Additional information proposed extension of existing quarry at  
Lots 58, 62, 66 & 69 corner Burfitt & Neville Road, Riverstone.

**ADDITIONAL INFORMATION**  
**PROPOSED EXTENSION OF EXISTING QUARRY**  
**AT LOTS 58, 62, 66 & 69**  
**CORNER BURFITT & NEVILLE ROAD, RIVERSTONE**

**J. WYNDHAM PRINCE & ASSOCIATES PTY LTD**  
**Civil Engineers**  
P.O. Box 795, PENRITH NSW 2750  
Phone: (047) 32 3366  
FACSIMILE: (047) 31 2821

**8 May 1990**

PLAN THREE

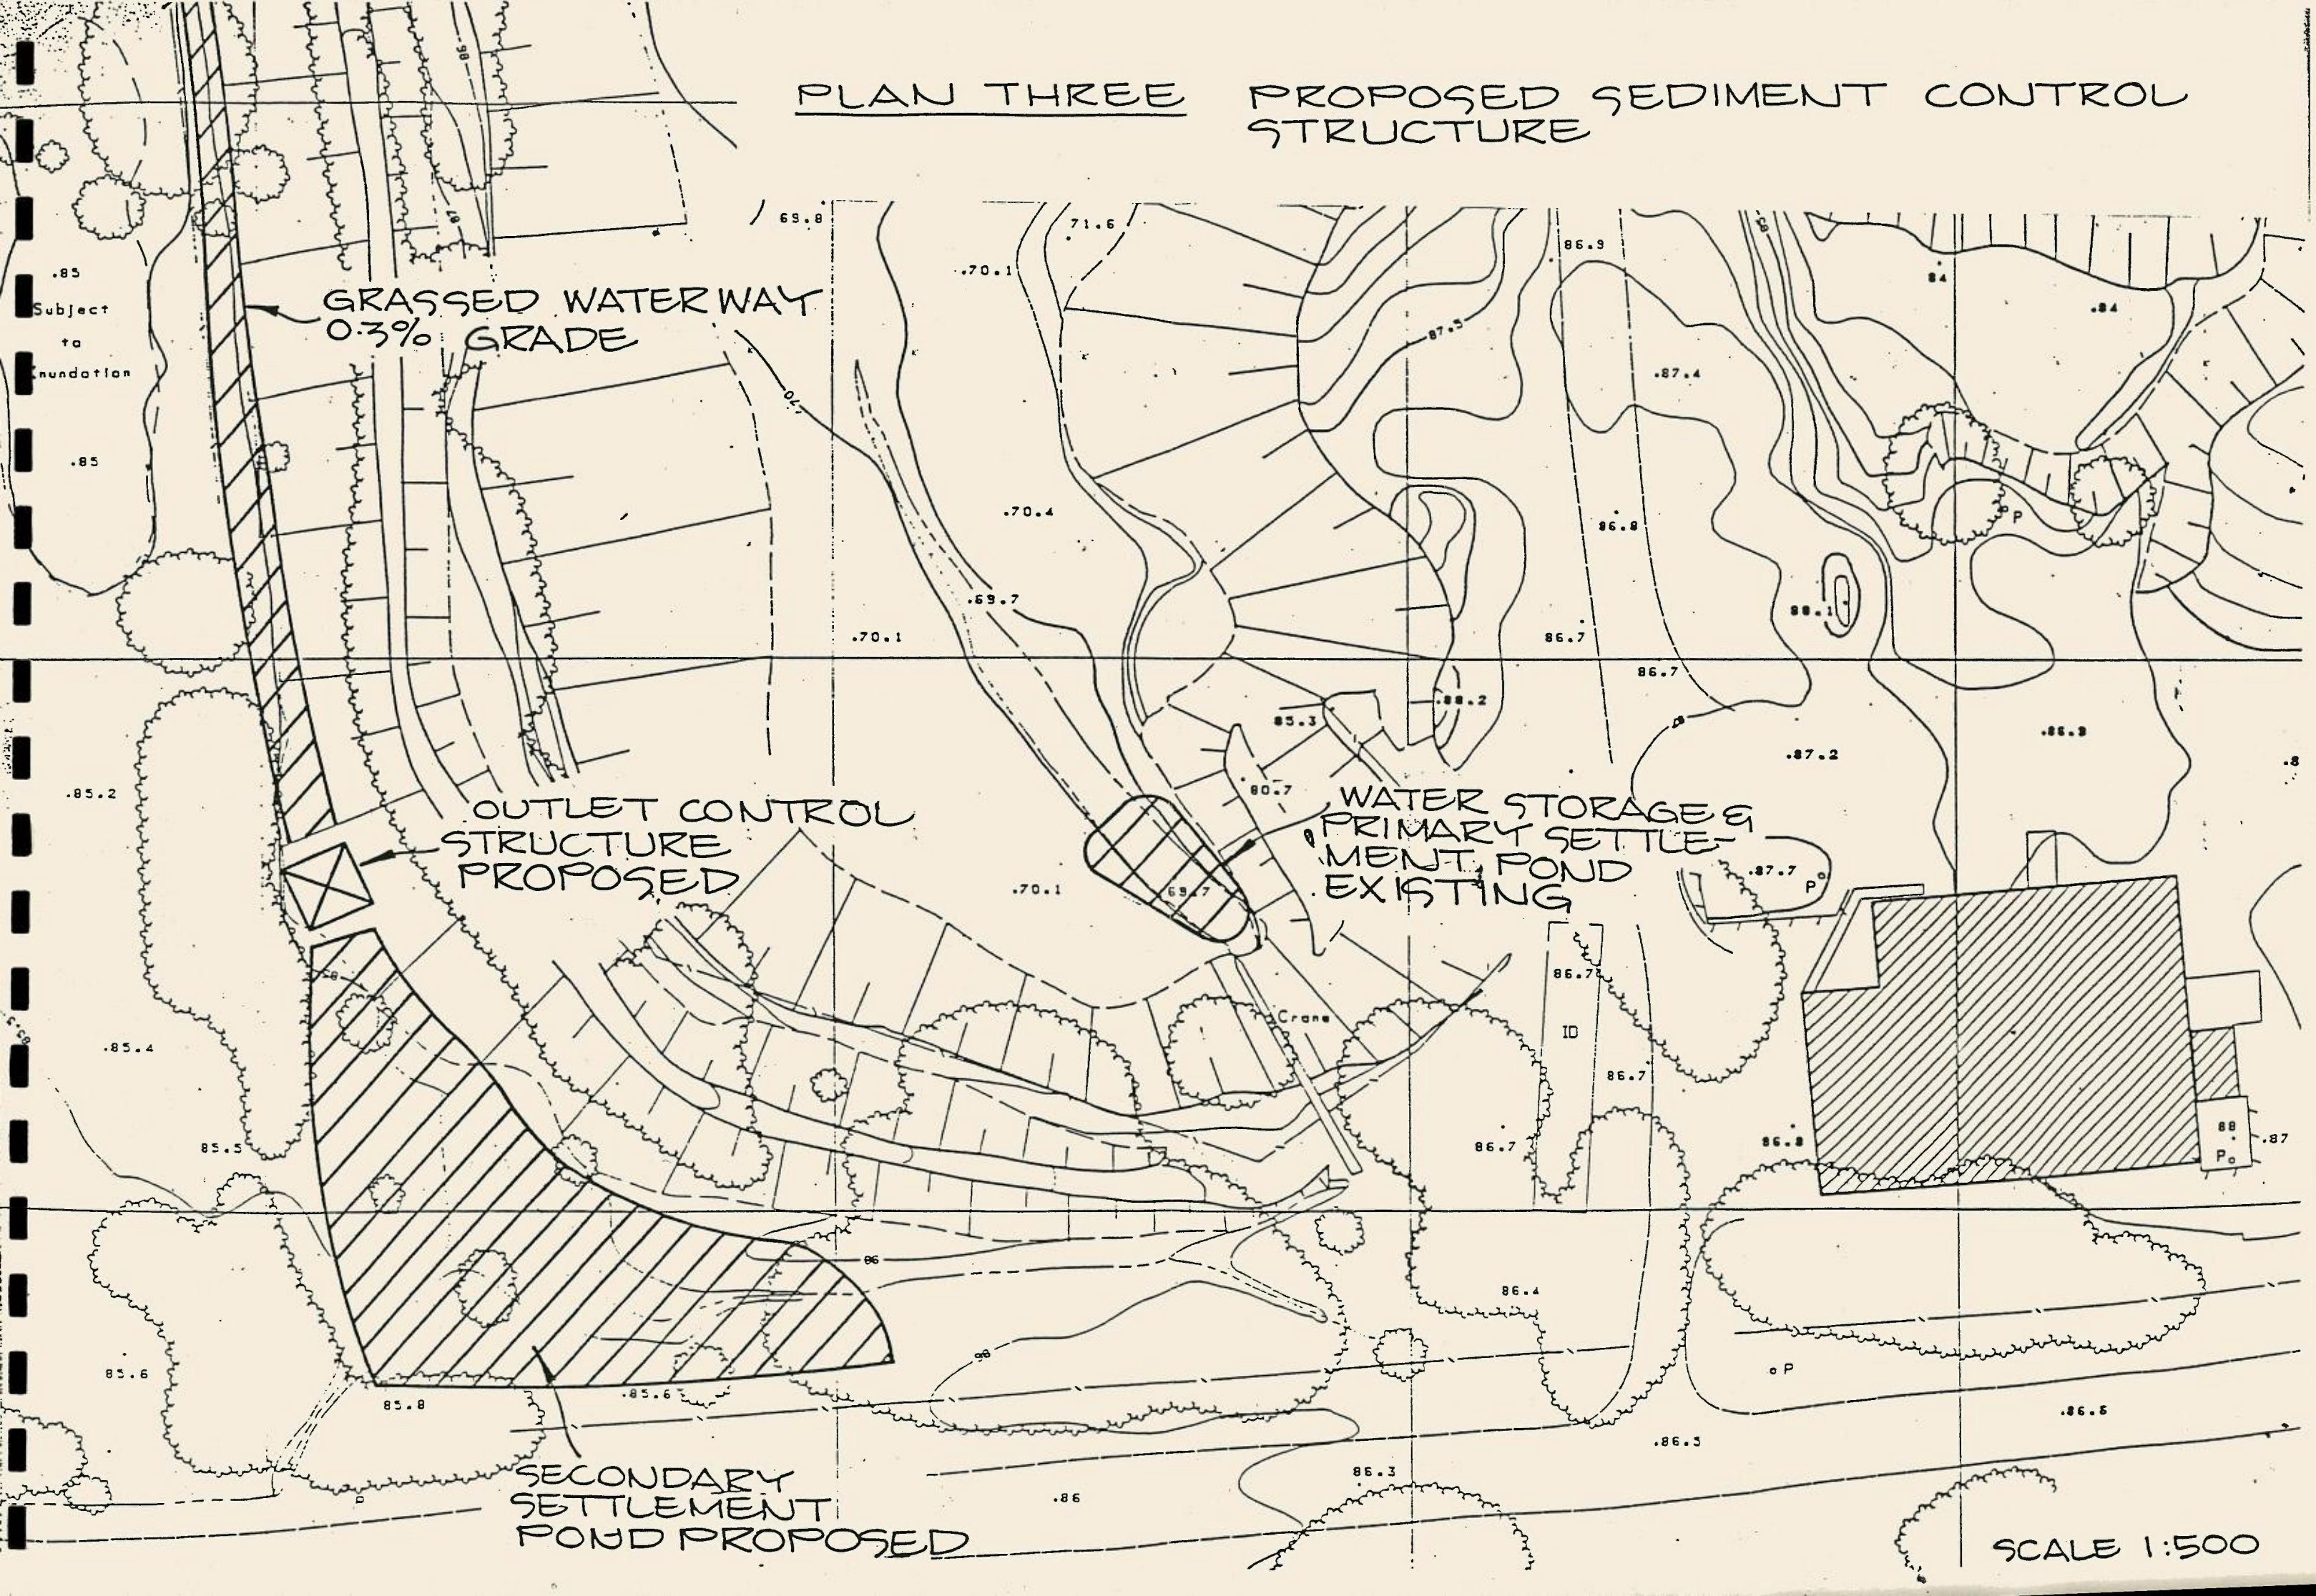
*why only 50%?*

*Need reassurance that discharge is clean - USE SPC guidelines to make sure of this.*

*Where does the silt go when it has built up?*

PLAN FIVE CROSS-SECTION PROPOSED BUND WALL  
SCALE 1:100

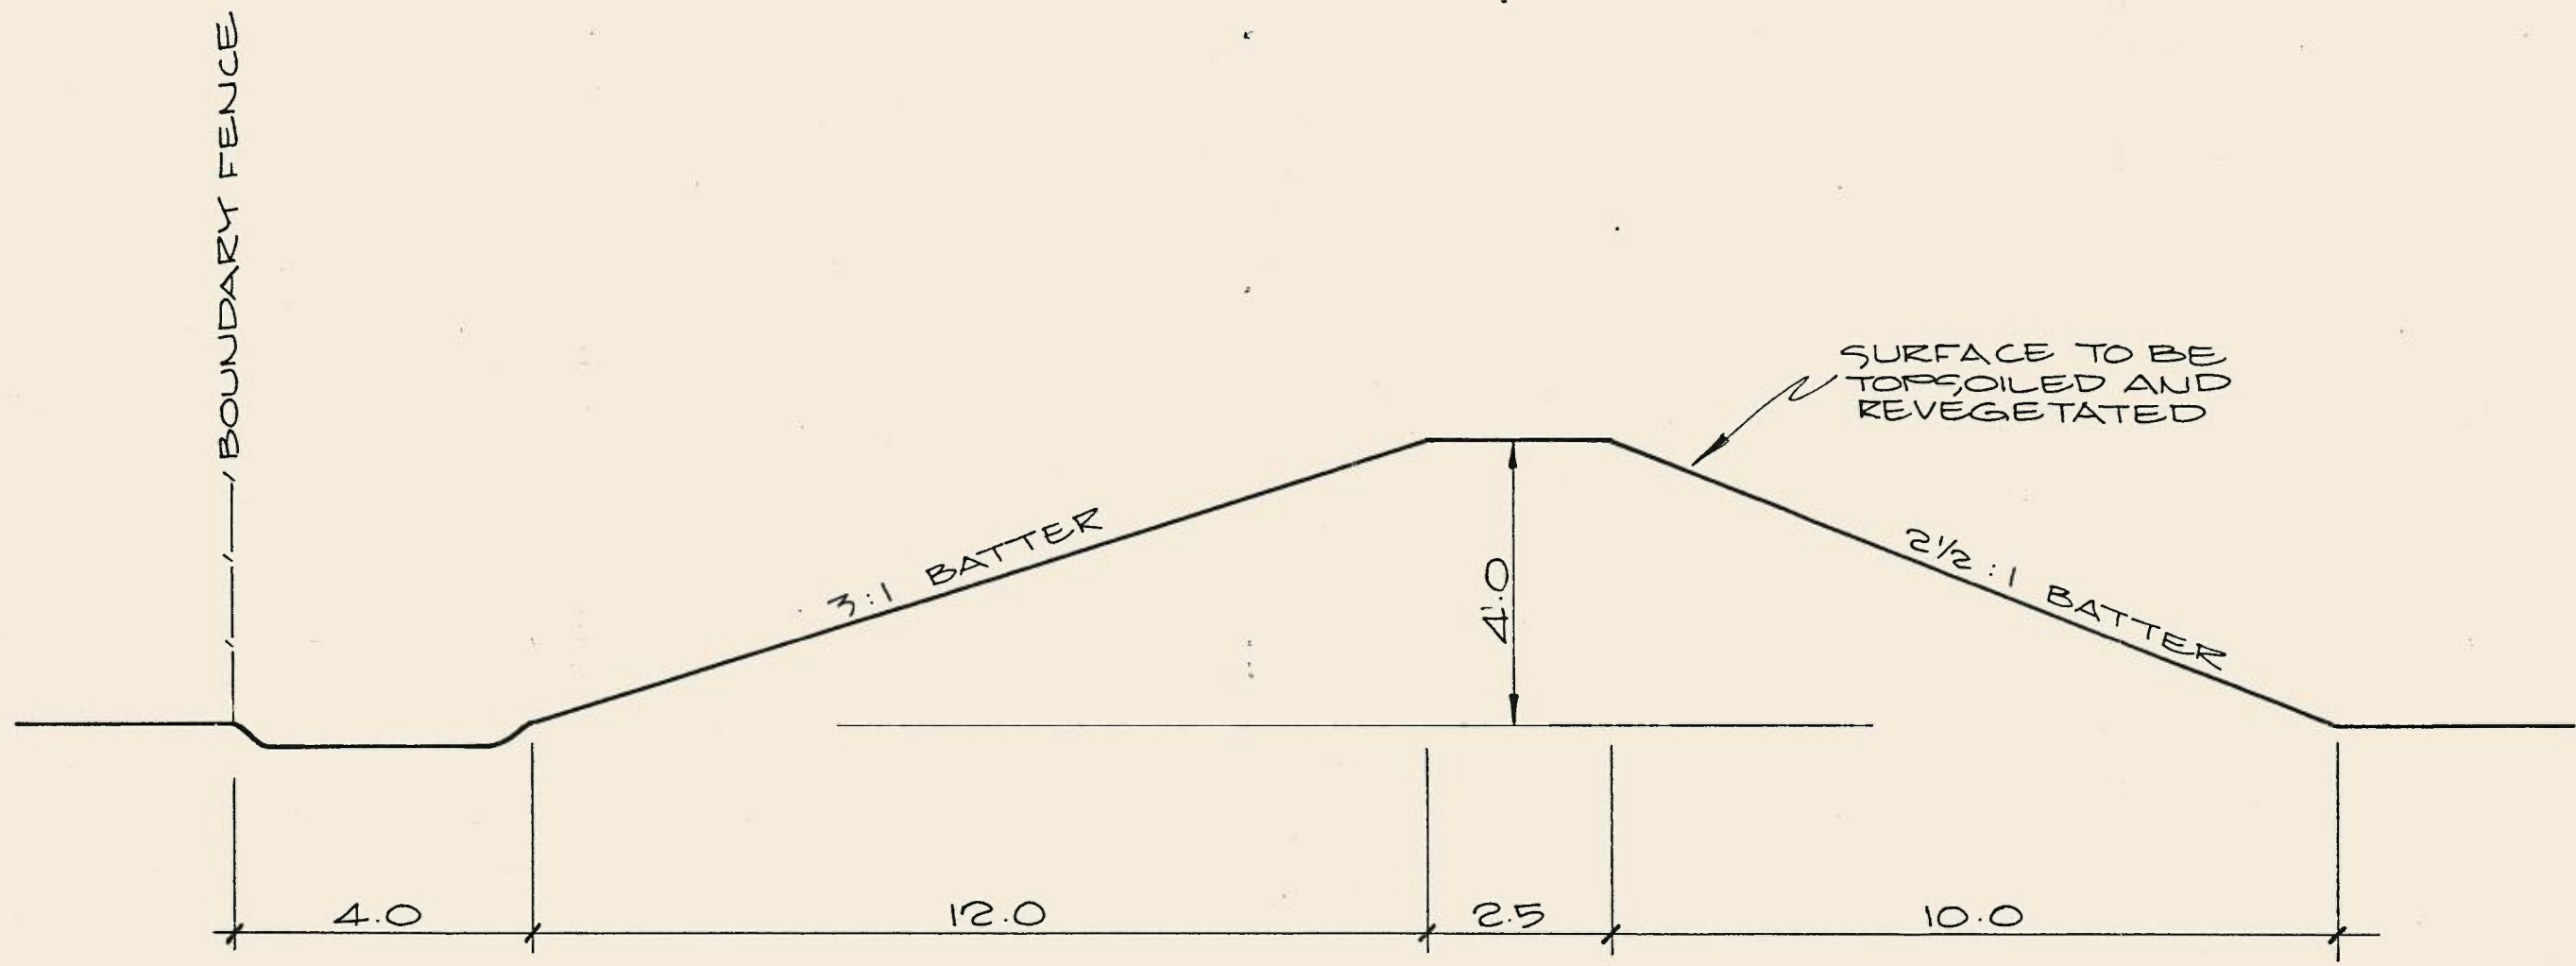
*what do they mean by this?*

*is this appropriate  
may need  
to get more  
detail -  
check with  
Chris*

\* will there be any further  
vegetation on bund wall e.g.  
Trees, shrubs etc. ?
